CITY OF WOONSOCKET
169 MAIN STREET
WOONSOCKET, RI 02895
401-767-9269
401-597-6604 Fax

TO: ALL BIDDERS
FROM: Jonathan R. Pratt, P.E., City Engineer
DATE: May 22, 2017
SUBJECT: Replacement of Operations Building Roof
– Bid# 5800

ADDENDUM #2

ANSWERS TO QUESTIONS FROM THE PRE-BID MEETING ON MAY 18, 2017

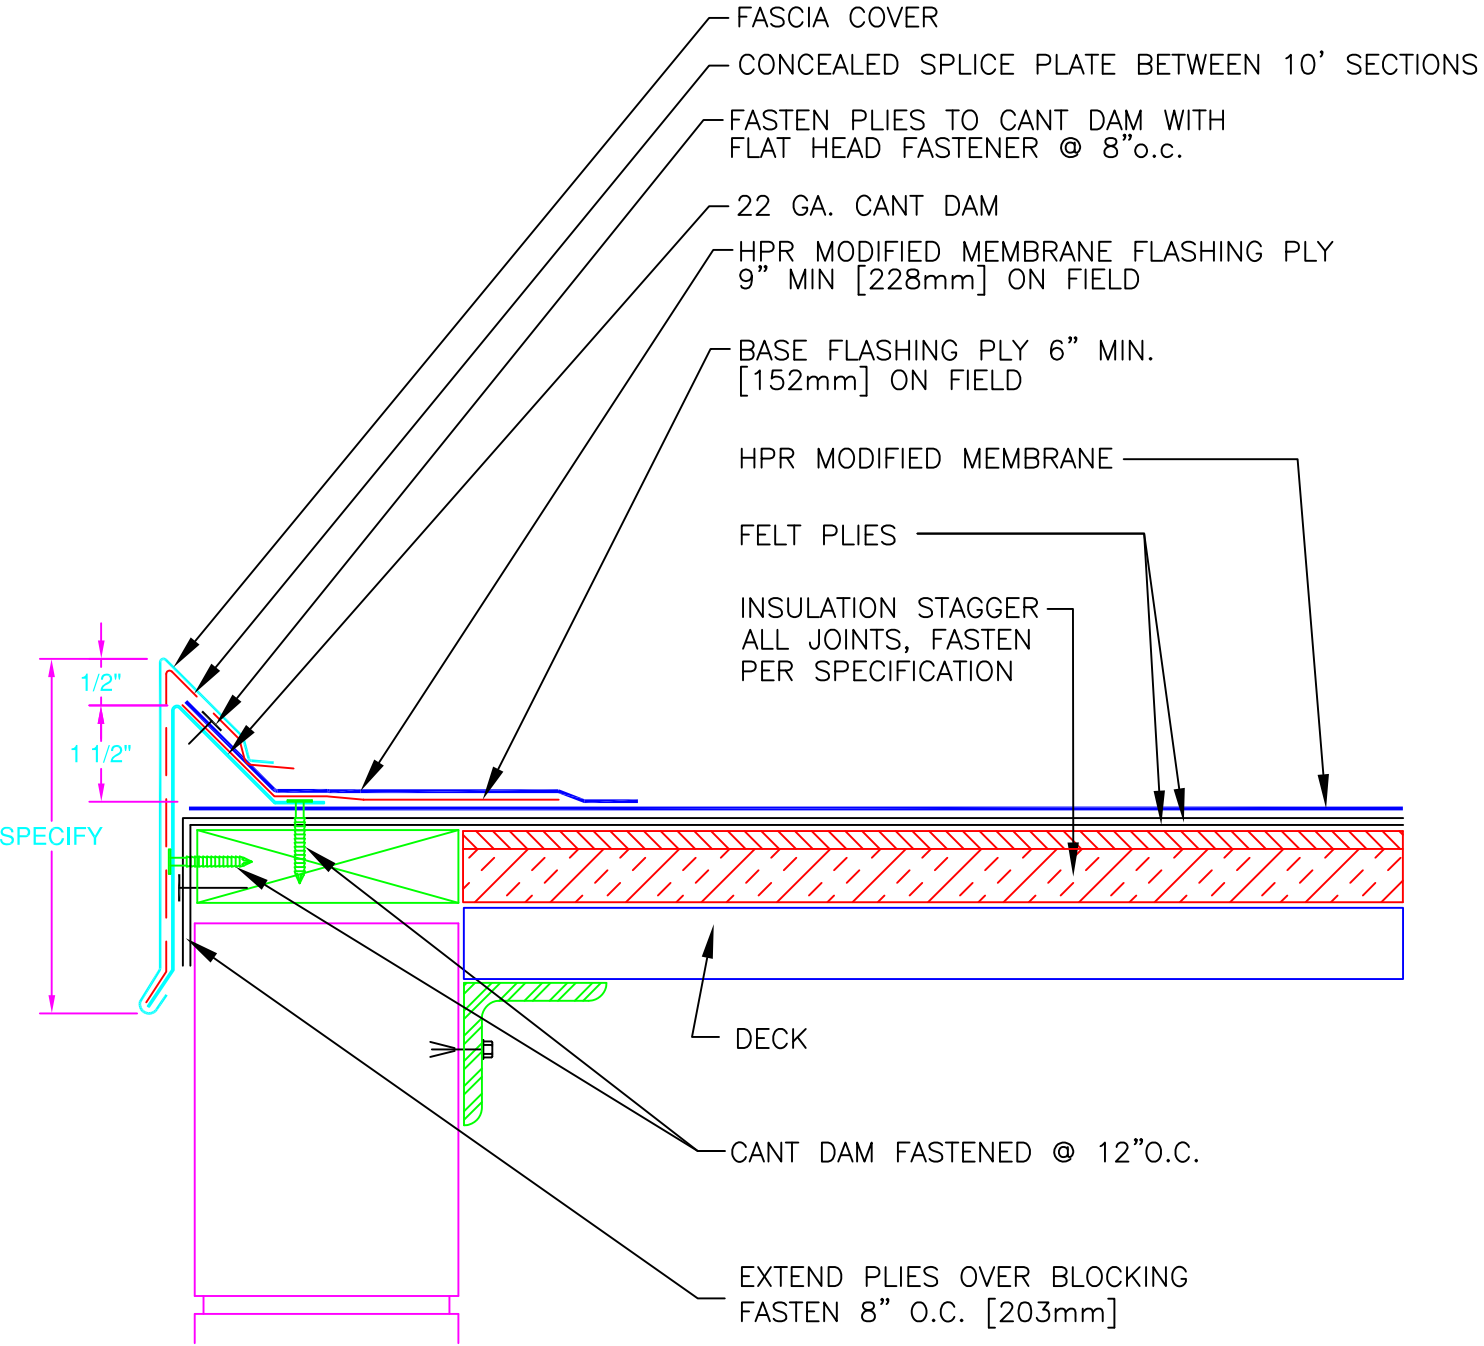
Q: Will a tapered insulation plan be provided?

The contractor is responsible for providing a tapered insulation plan to be submitted for approval. A base layer of R25 is required. The concrete deck is believed to be structurally sloped at 1/8". The tapered insulation should be designed to achieve ¼" total slope.

Measurements are to be confirmed by the contractor.

THROUGH WALL COUNTERFLASHING

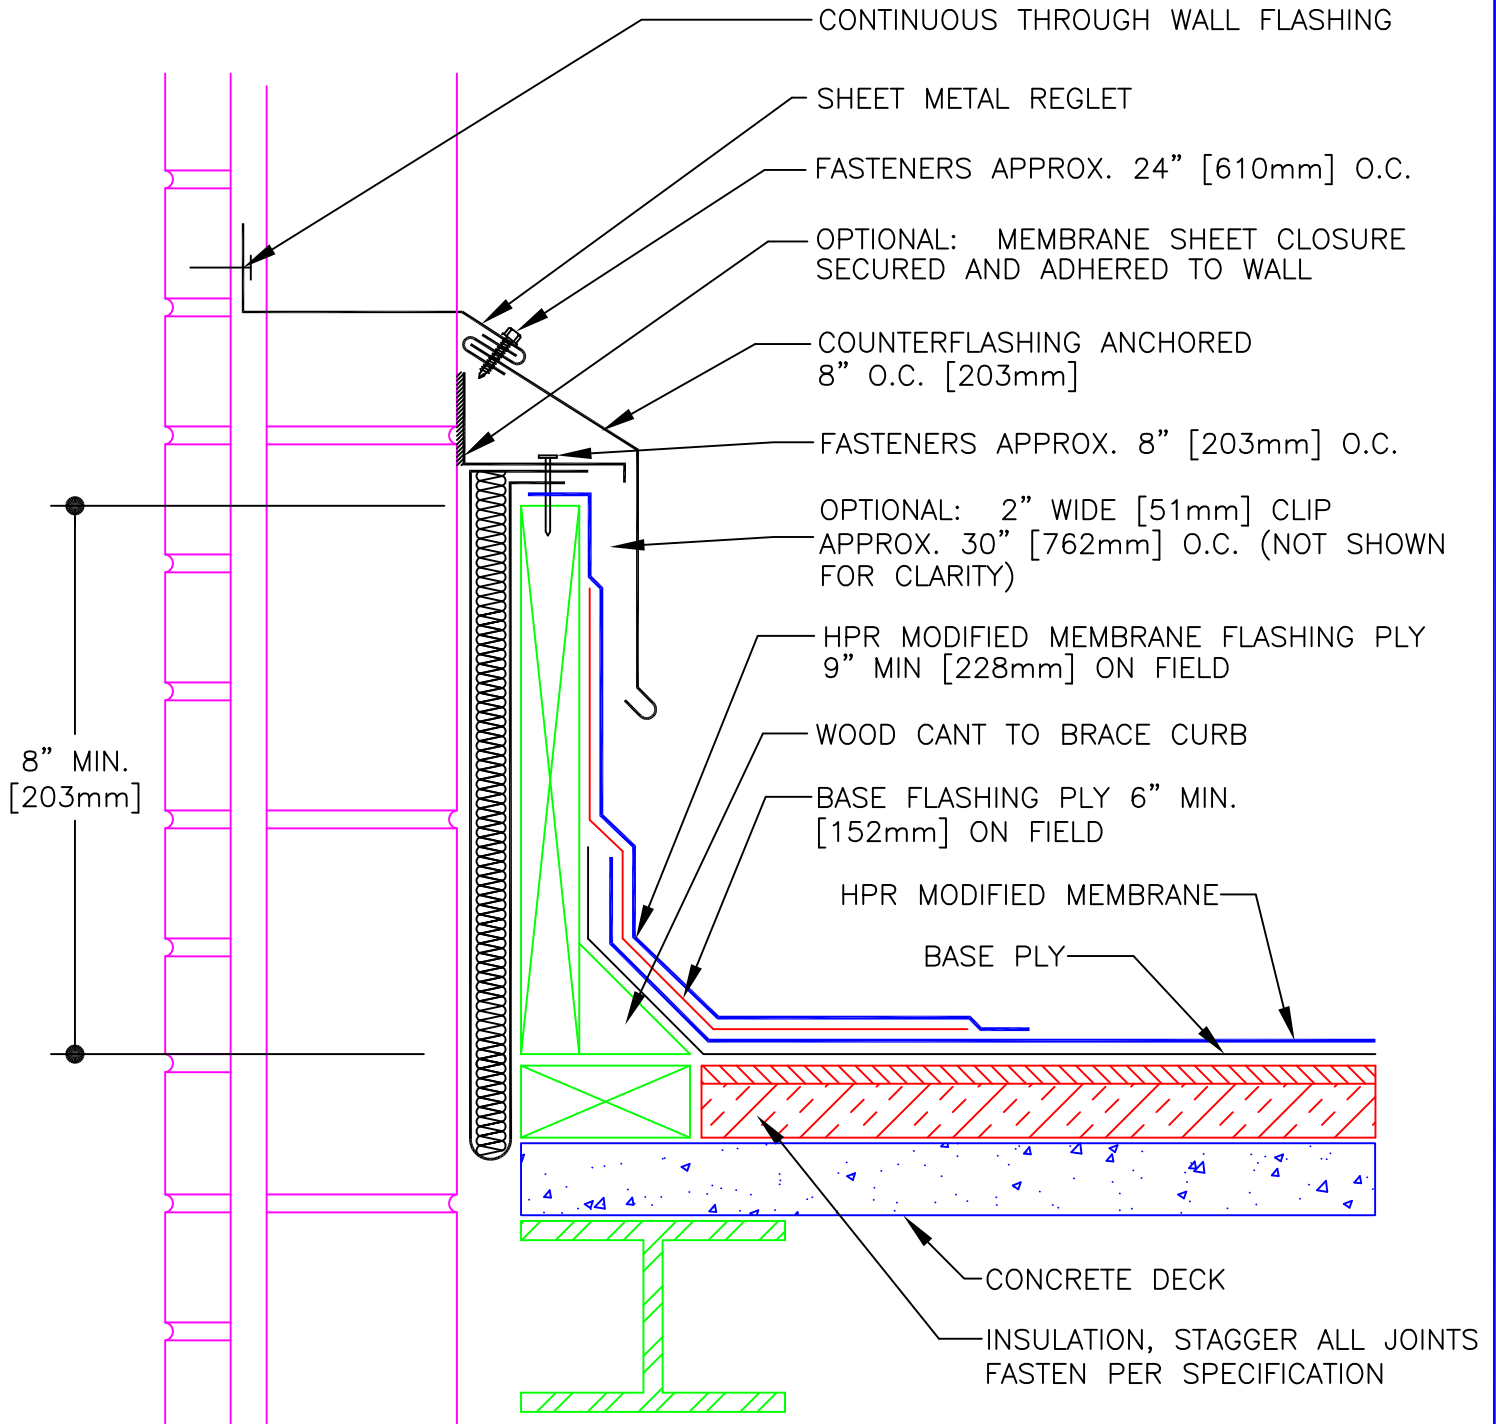
Q: How will the wall flashing be addressed on the connector roof?

The thru-wall counter-flashing is to be raised to meet the new insulation heights and achieve an 8" minimum flashing height.

EXPANSION JOINT

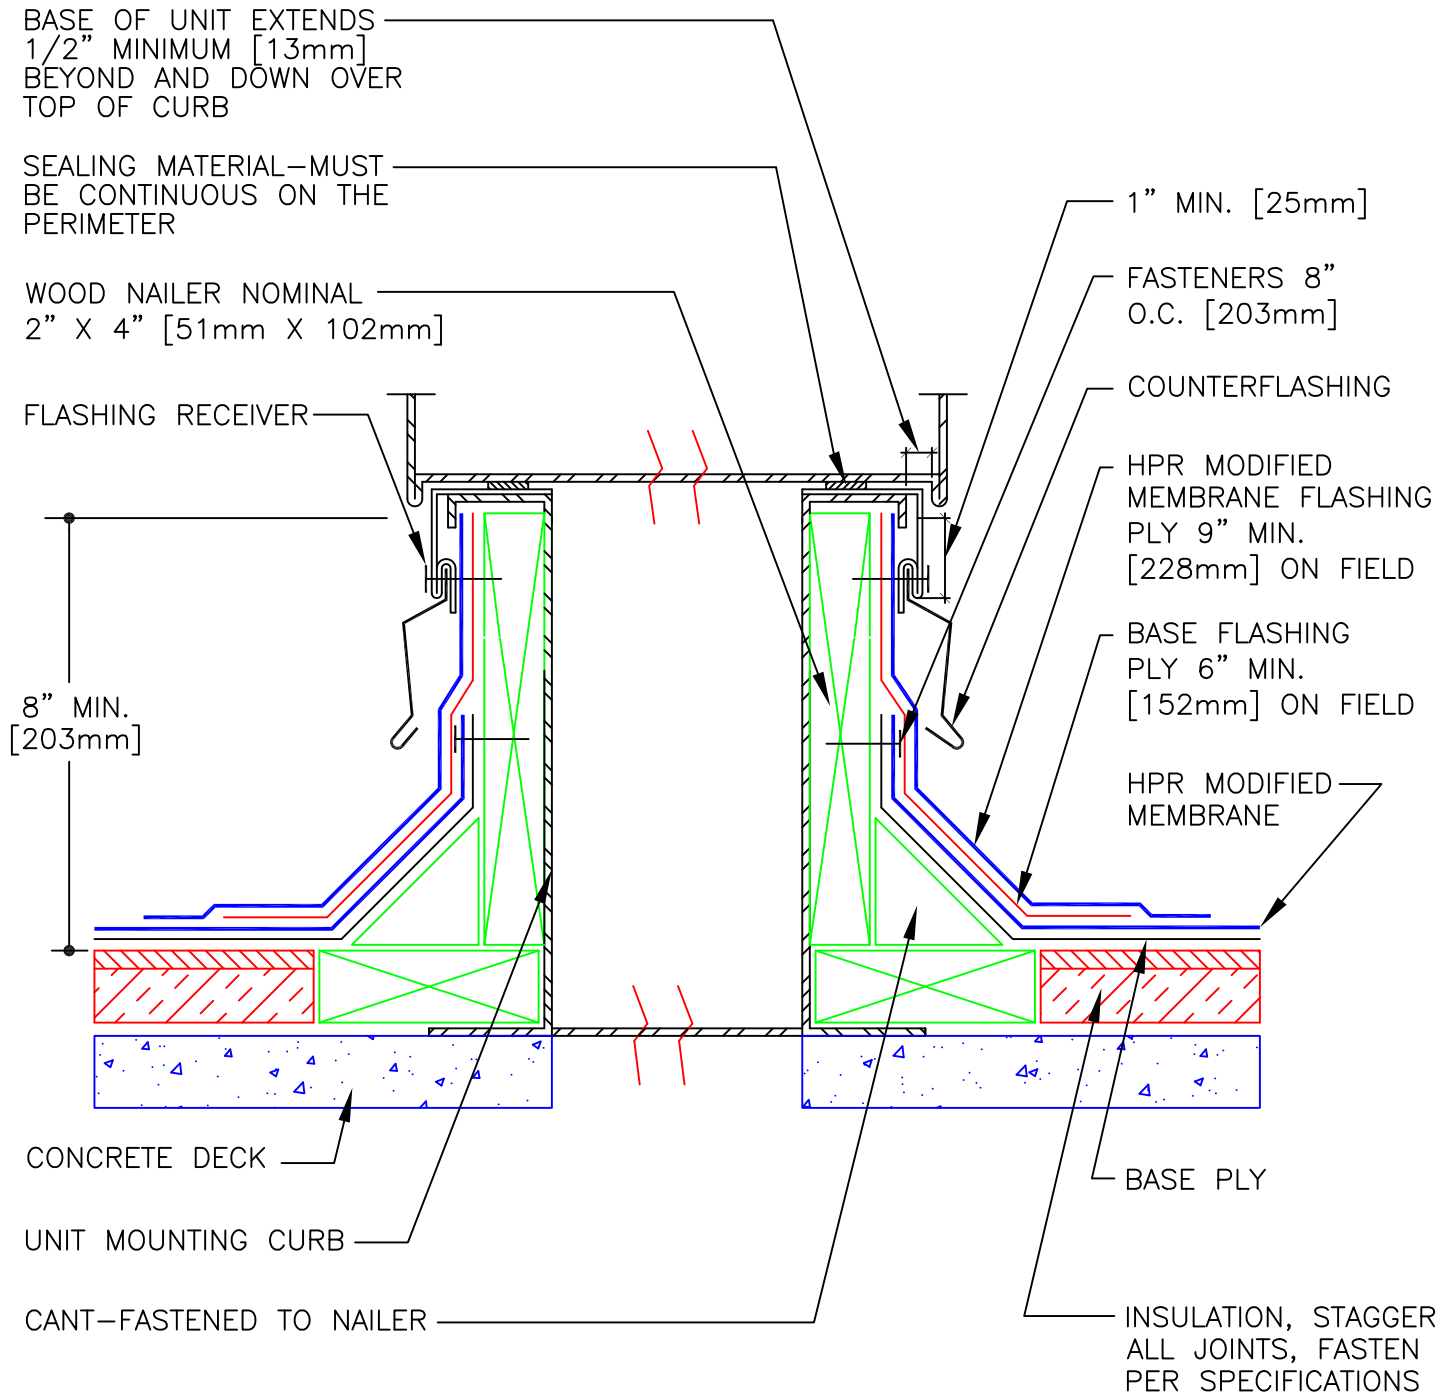
Q: How will the expansion joint detail be addressed at the transition between the BUR and TPO roof assemblies?

The contractor is to remove the existing termination bar, install the new 2 ply flashing system, terminate flashing plies, and install a new aluminum expansion joint cover over the transition.

Roof System Composition

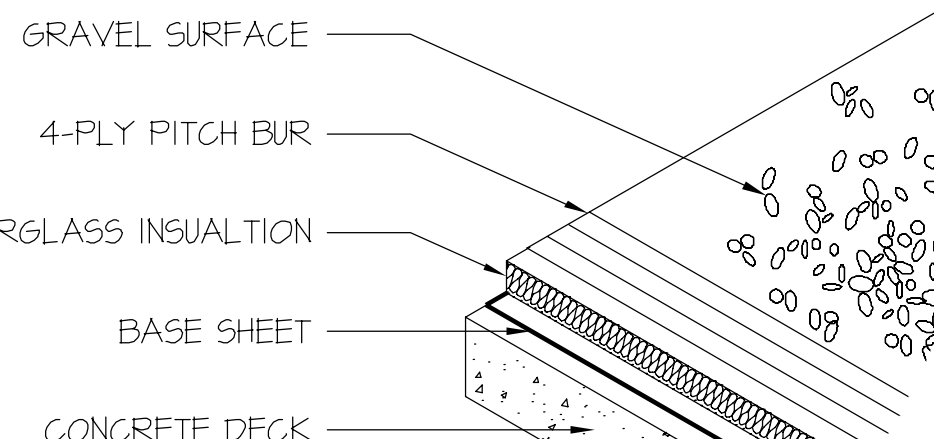
Q: Is the core composition available?

See the core composition detailed in the attached document.

Layer No	Layer Type	Thickness	Attachment	Condition
1	Concrete Tee's	N/D	Mechically Attached	Good @ Test Cut
2	Base Sheet (vapor barrier)	1 Ply	Mopped in Asphalt	Poor @ Test Cut
3	Polyisocyanurate Insulation	2 Inches	Mopped in Asphalt	Poor @ Test Cut
4	Perlite Insulation	1/2 Inch	Mopped in Asphalt	Poor @ Test Cut
5	Fiberglass Felt Asphalt BUR	3 Plies	Mopped in Asphalt	Poor @ Test Cut
6	Flood Coat & Gravel	N/D	Poured	Fair
